COMMONWEALTH of VIRGINIA

DEPARTMENT OF ENVIRONMENTAL QUALITY
Street address: 629 East Main Street, Richmond, Virginia 23219
Mailing address: P.O. Box 1105, Richmond, Virginia 23218
TDD (804) 698-4021
www.deq.virginia.gov

August 2, 2010

**Summary of a Safe Yield Analysis for the Rivanna Water and Sewer
Authority System
DEQ Office of Surface and Ground Water Supply Planning
August 2, 2010**

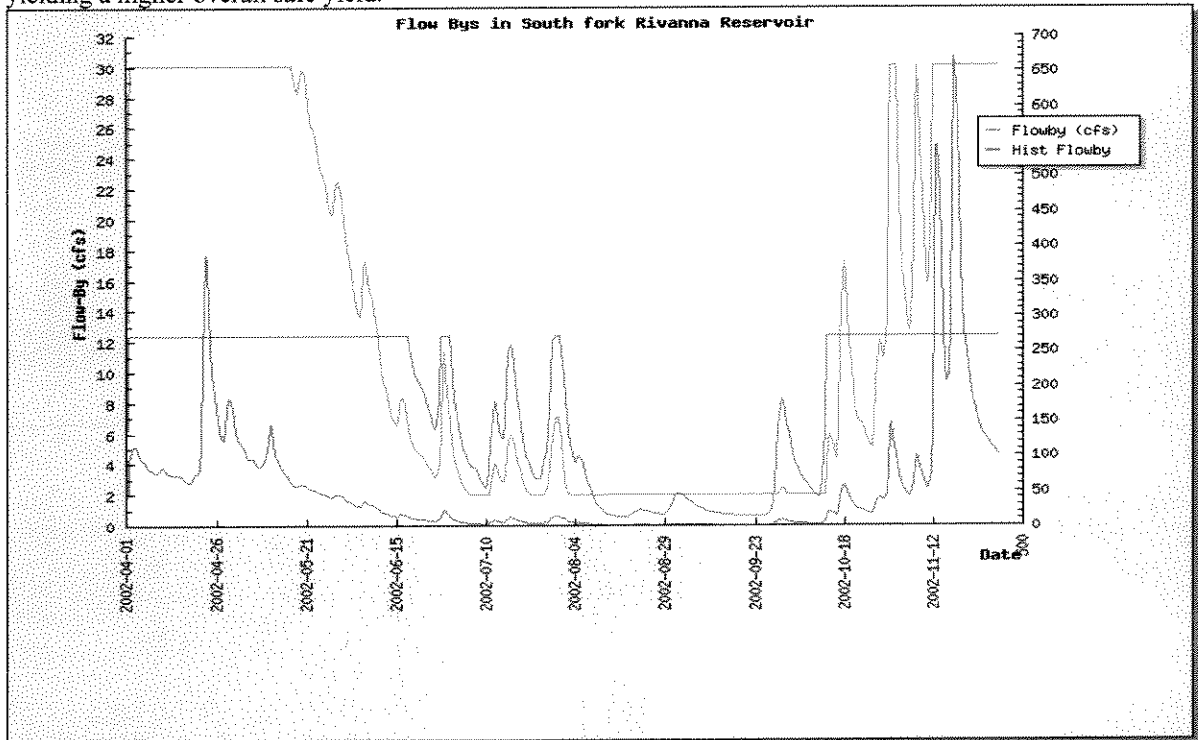
One interesting outcome of the current permit is that the flow-bys are generally maintained at a higher level under typical conditions and on average over the whole period modeled than under the historical operating conditions. However, under the most severe drought conditions, two trade-offs occur: 1) the single day and 7 day low flows decrease out of the South Fork reservoir, and 2) the refill time for South Fork reservoir increases. Thus, while the reservoir is allowed to hold back more water during the driest times, it comes at the price of replenishing storage more gradually. This can be seen in Figure 1, where the new flow by becomes less than the historical flow-by in mid-June,

and continues to be smaller until mid-August. In mid-October and through November the new flow-by again begins to increase relative to the historical voluntary flow-by as system storage begins to rebound (see Table 3). Figure 1 is a hypothetical comparison of flowbys in the South Fork Reservoir under the historic operational conditions and the operational conditions in the VWP permit.
